# **Comments On Background Information For A Proposed Algonquin Provincial Park Management Plan Amendment**

**Submitted on March 3<sup>rd</sup>, 2010  
by the Algonquin Backcountry Recreationalists**

This submission contains specific observations and concerns. It includes both text comments and illustrations which have been extracted from the ABR's "Camp Values Inventory" side-by-side map-comparing utility. Comparisons are drawn between the 2009 Canoe Route Map and the OPB/AFA Joint Proposal High Definition Map. (13 pages)

CVI-SM6b-Highlands.jpg

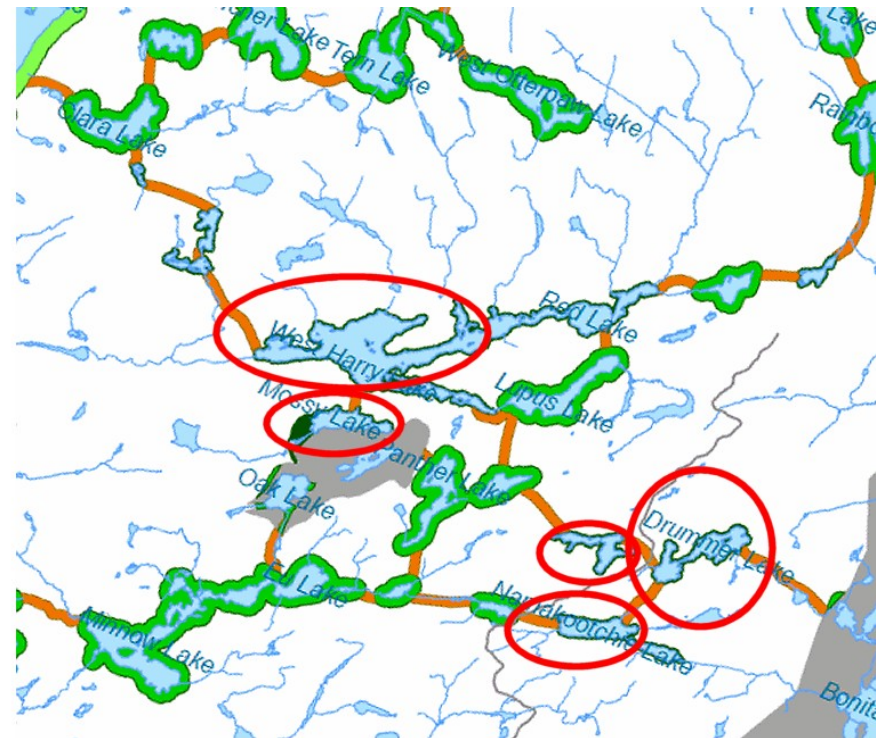
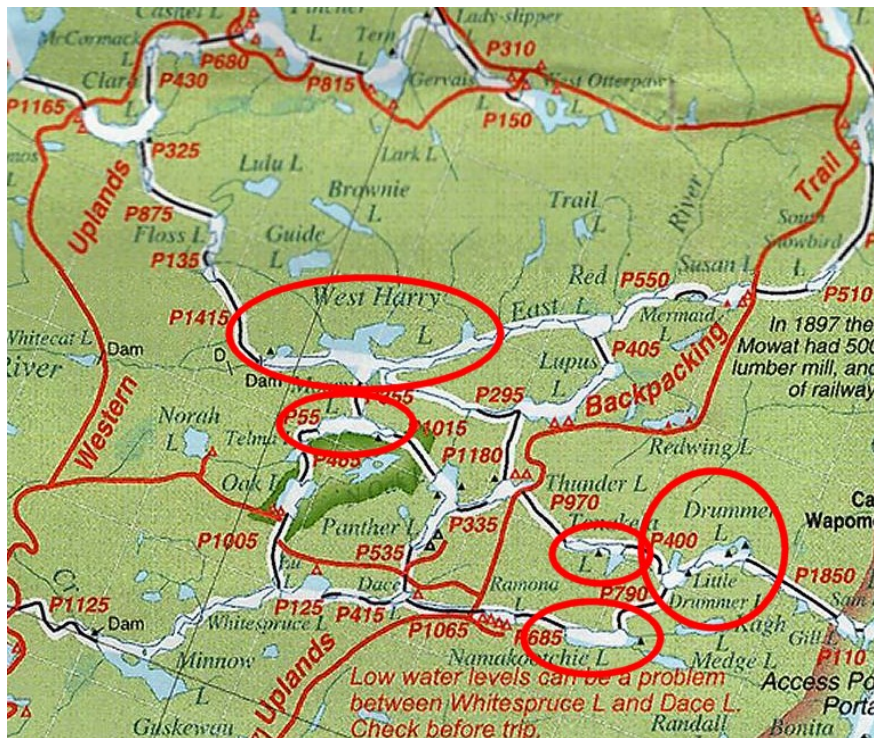
A number of lakes in the Western Uplands area have backcountry canoe campsites on them, but have only been assigned minimal zoning setbacks.

The ABR believes that, in order to maintain consistent wilderness-like aesthetics, these Western Uplands canoe campsite lakes warrant 120 meter protective setback zones.

The affected lakes include ... West Harry Lake, Mossy Lake, Tonakela Lake, Drummer Lake, Little Drummer Lake and Namakootchie Lake.
